Change Order Request

PFAS Well 15

Field Order 11- Curb at Generator Area

FO#11

FOUNDATION PLAN

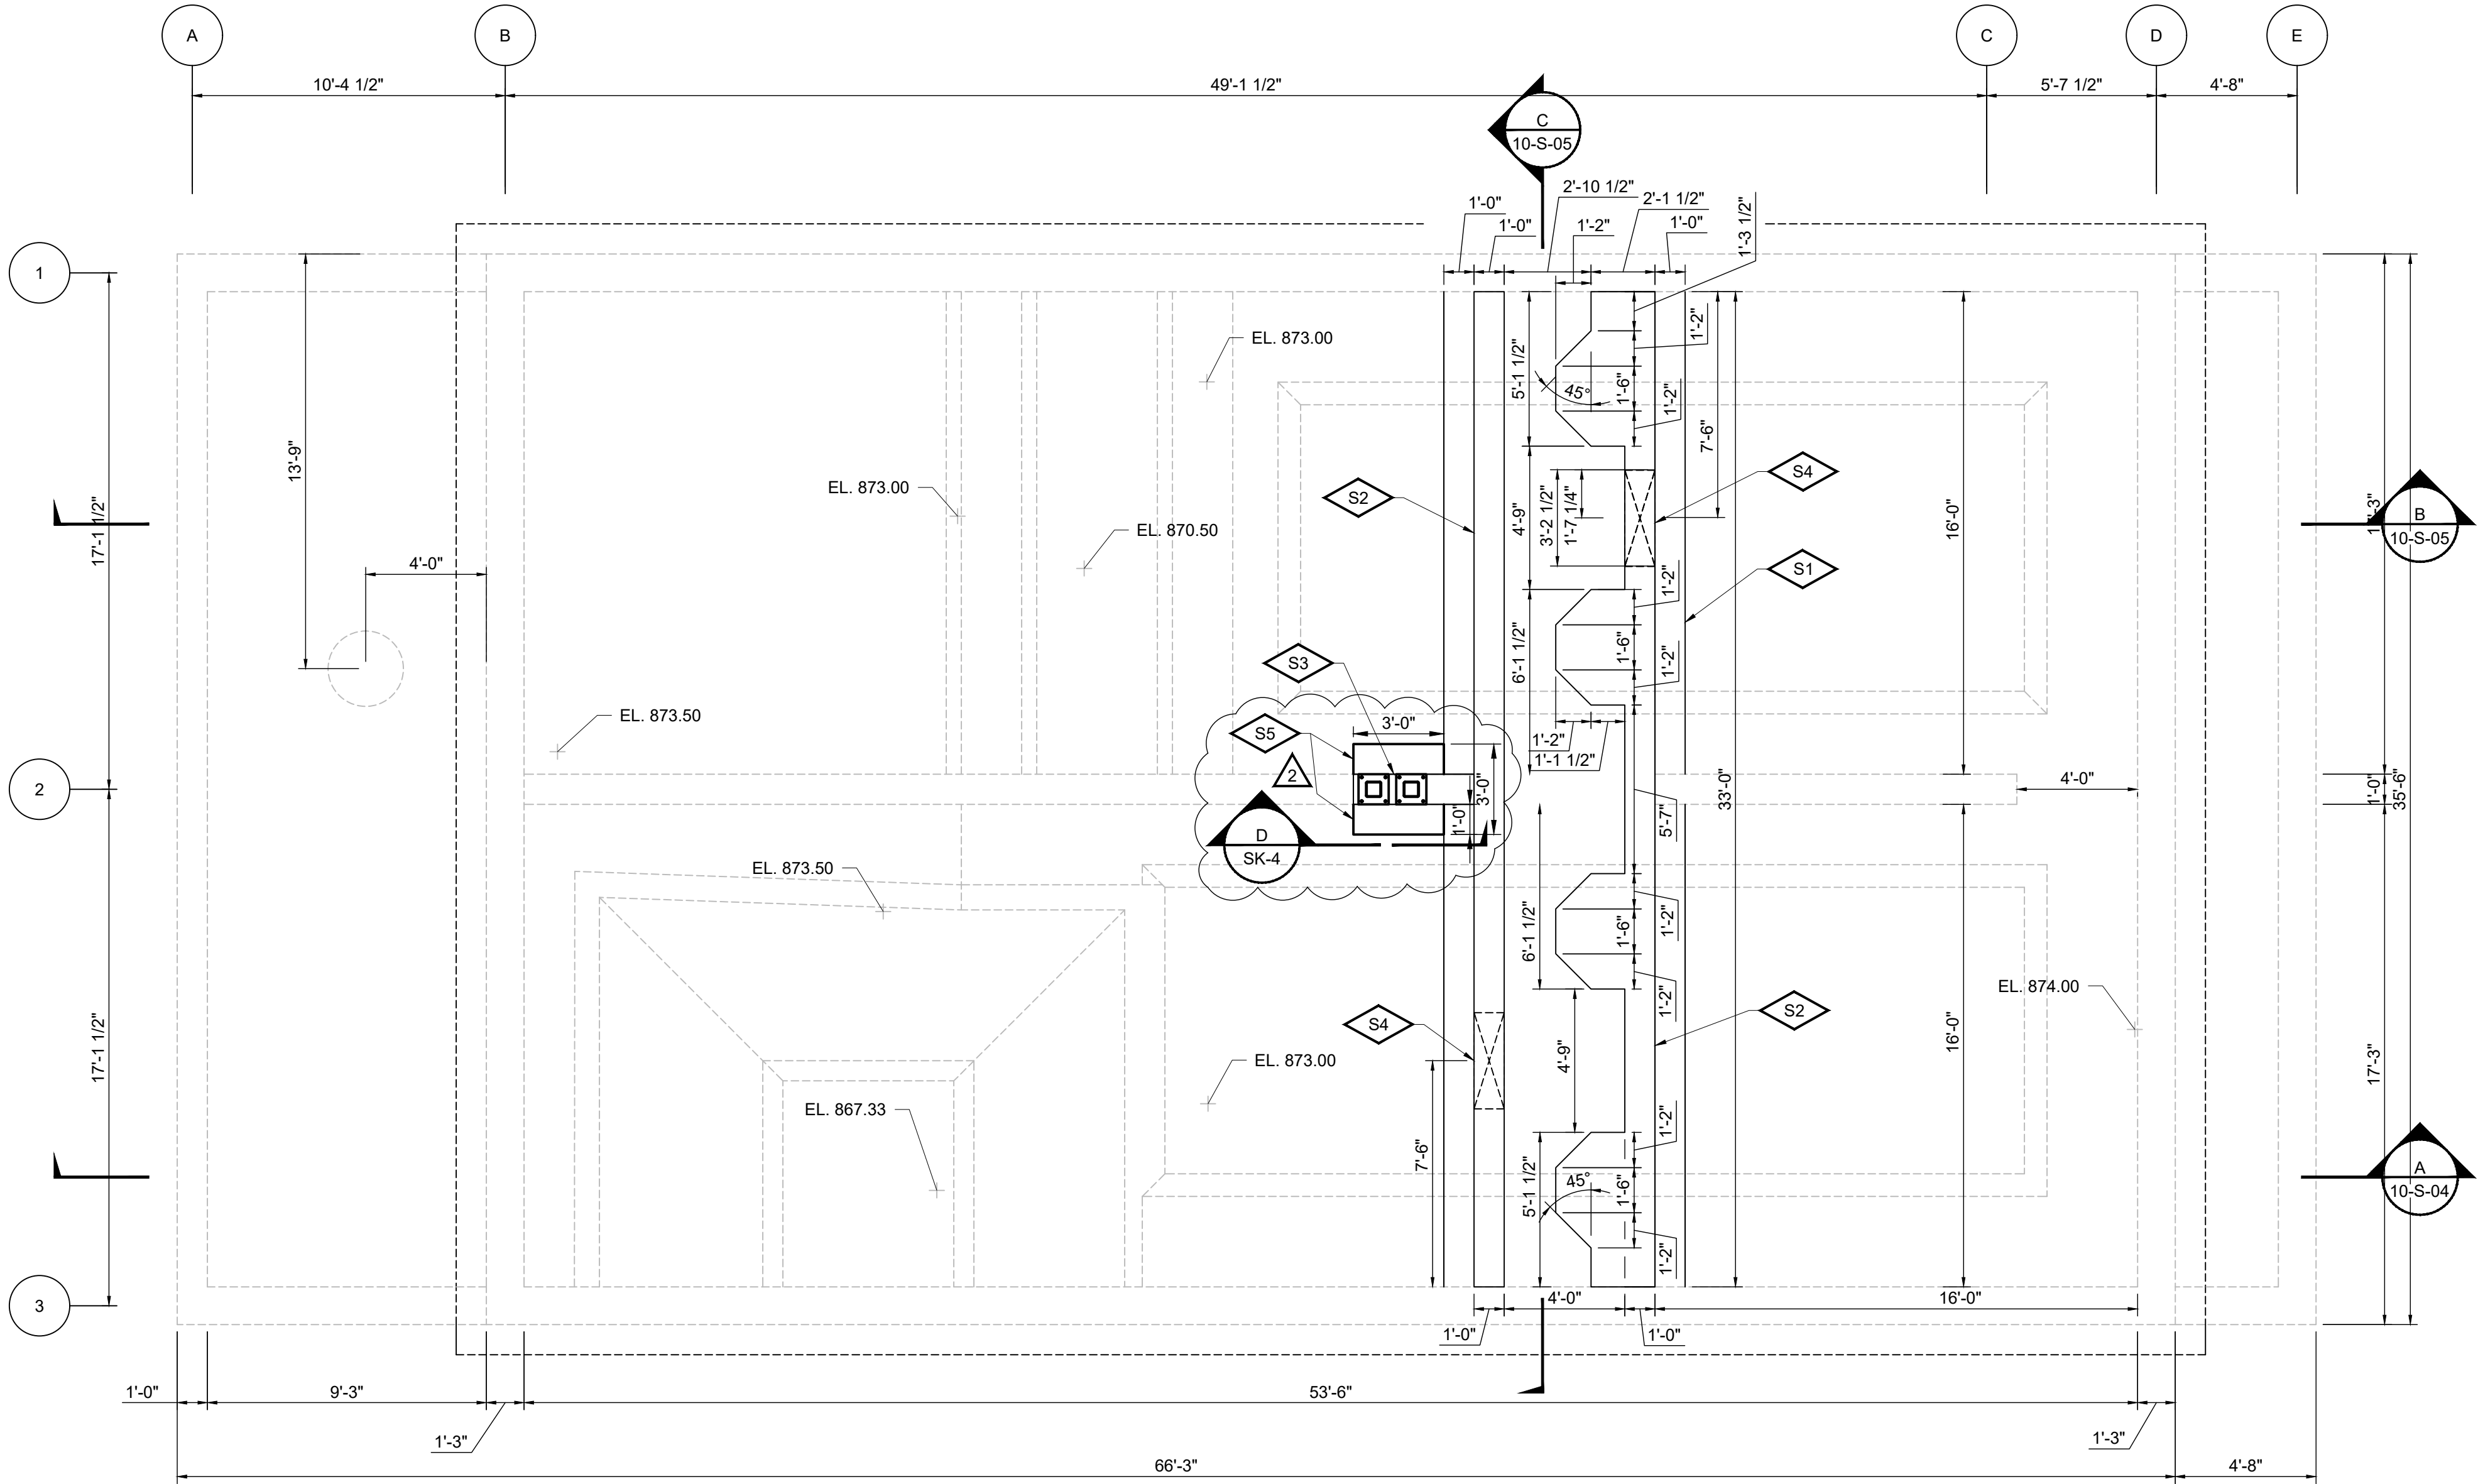
- S1 CONSTRUCT BASE SLAB TO BE PLACED ON TOP OF EXISTING SLAB
- S2 CONSTRUCT 12-INCH CONCRETE WALL
- S3 NEW OPENING IN WALL TO PROVIDE FLOW BETWEEN TANKS
- S4 ACCESS MANWAY OPENING IN WALL. SEE DETAIL SHEET 10-S-06.
- S5 REFER TO DETAILS ON COLUMN AND FOUNDATION. DWG. SK-4. RESPONSE TO RFI #35.

2	10/21/2024	RESPONSE TO RFI #35
1	12/22/23	ISSUE FOR BID
I/R	DATE	DESCRIPTION
